British Gas comments on the Proposed Allocation of Unidentified Gas Statement (AUGS) for 2019/20

21 January 2019

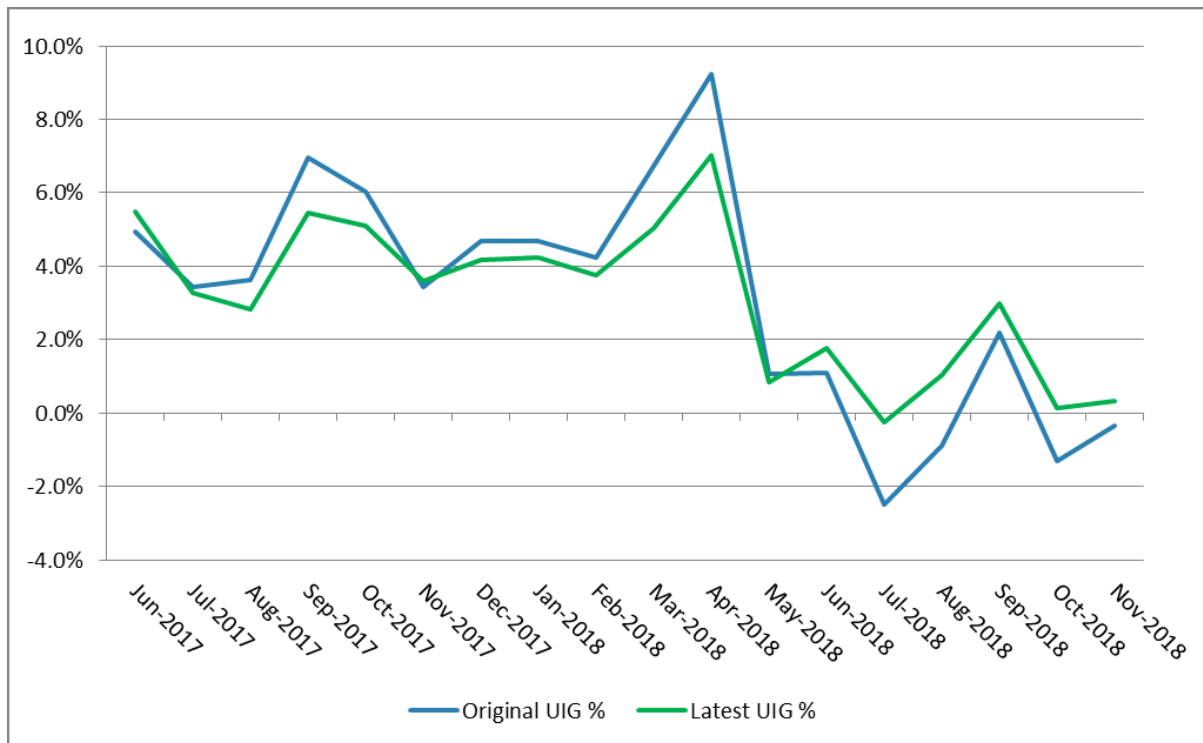
Since the start of the current gas year, with the application of the new scaling factors for 2018/19 which effectively increase initial allocation by 7% for EUC band 1 sites, average national UIG has been -0.4%. This change from a positive to negative UIG levels at allocation may be having unintended impacts. For example, the now beneficial initial UIG is being allocated at the highest rate to EUC bands 2 and 3 in PC4, which aren't impacted by the new scaling factors. It is not clear whether this will even out through subsequent reconciliation and UGR smearing.

We would like the AUGÉ's views on the interaction between the UIG allocation table and the proposed demand estimation methodology for 2019/20, as well as any observations for the current gas year.

UIG is calculated as a small difference between two very large numbers (i.e. input to the system and output from the system) and is hence extremely volatile. Our experience from years of calculating Unidentified Gas figures is that when you assign it to individual years the figures for these years are very variable, and it is only across a number of years that the genuine prevailing level becomes apparent. As such, it is not unusual to have periods of time where the average value appears to be very large (such as the 4.6% average from 2017) or very small (such as the current level of -0.4%).

Therefore, whilst the effects of these changes will endure, and result in initial UIG values that are consistently lower than the 2017 average of 4.6%, the remaining difference (which is due to natural variation) will continue to operate in an unpredictable manner. As such, we do not believe that UIG will continue to operate at a value as low as -0.4% indefinitely, although initial UIG is likely to continue to run at this level at times. The following graph, produced by the CDSP, shows a number of interesting features:

- The 2017-early 2018 level of 4.6% can be clearly seen, along with the current level where original UIG has been negative on average since June 2018.
- Where UIG is high, reconciliation is bringing the value down, whilst where it is low, reconciliation is raising it back above 0%. This shows that the old initial UIG of 4.6% is an over-estimate and the new initial UIG of -0.4% is an under-estimate.

- As far as the AUG Expert’s analysis of Unidentified Gas is concerned, it is the green line - the current best estimate of UIG(f) – that is important. The current level of this is above zero and hence any incentive to keep sites in a high-UIG Product Class applies only to initial UIG and is lost over time.

- There is a clear step change in the level of original UIG around May 2018, which cannot be completely explained by weather effects or the ALP/DAF uplift factors. Whilst it is understood that low temperatures tend to lead to high levels of initial UIG and high temperatures lead to low (and potentially negative) levels, the time periods covered by the two distinct levels in the graph include a wide range of average temperatures. The “high” period covers a full year, whilst the “low” period runs from the summer heatwave right through to cold weather in November.

- Whilst weather remains a factor that influences original UIG, we conclude that there is therefore another factor that has also impacted on these values. We believe that the step change is likely to be due to successful measures taken by the CDSP to increase the accuracy of calculated UIG.

- As stated above, the current best estimate of final UIG (the green line on the chart) is above zero. Original UIG is an under-estimate of this, however, and has been running at an average of -0.4%: the figure only returns to its expected above-zero value when reconciliations are taken into account. If the current level of UIG continues (i.e. the new level is indeed the result of improvements made by the CDSP) and the nature of original UIG results in the kind of initial under-estimate that has consistently occurred for the last 6 months, this pattern may continue. If this is the case, it may be prudent to investigate options for improving the original UIG calculation to prevent it being negative and creating an initial UIG credit rather than debit.

- Whilst it is recognised that the current UIG levels result in an initial benefit, this situation is reversed when reconciliation occurs and the true level of UIG is revealed. Therefore, any initial UIG credit based on original UIG values is only temporary and should not result in deliberate uptake of Product Classes that attract more UIG. It can be argued that this situation creates a disincentive for suppliers to read meters and allow allocations (and hence original UIG) to remain in place. Meter read frequency requirements are specifically stated in the UNC, however, and any such strategy would put a supplier outside the rules and mean they were failing to fulfil their obligations.
